Chapter 5. Galveston Ring Barrier and Seawall

Figure 5-2. Ground elevation contours inside the Ring Barrier

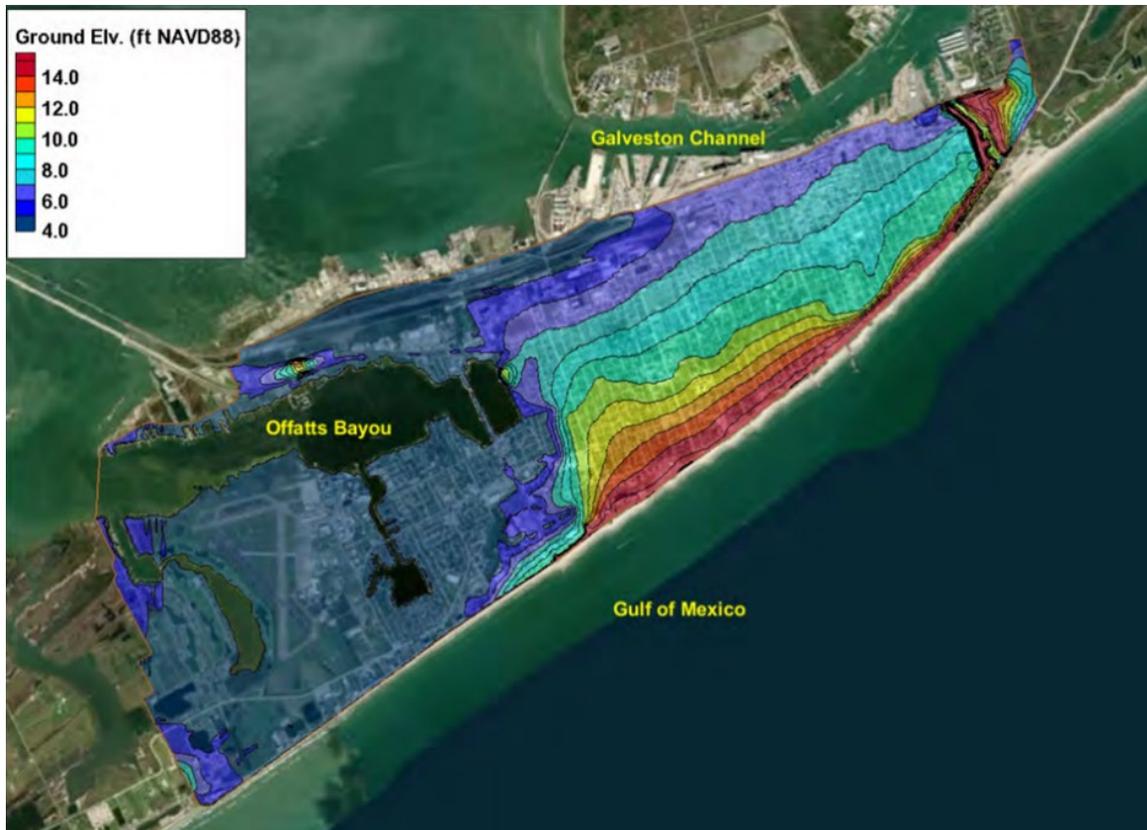
Design of the western half is complicated because of the flat low topography and numerous flows into a gated Offatts Bayou.

Figure 5-2 provides a clear illustration of just how vulnerable the City is to flooding from the bay side, even with the USACE Plan in place. The with-project 100-yr water surface elevations (WSE) on the bay side of the City of Galveston range from 10 to 12 ft NAVD88 for present sea level. They are estimated to be approximately 2 ft higher (12 to 14 ft) for the intermediate-rise future sea level scenario. Areas in the City that are lower than the yellow-shaded area shown in Figure 5-2 are inundated for a WSE of 11 ft, which is nearly the entire City except for the small higher areas immediately adjacent to the Seawall.
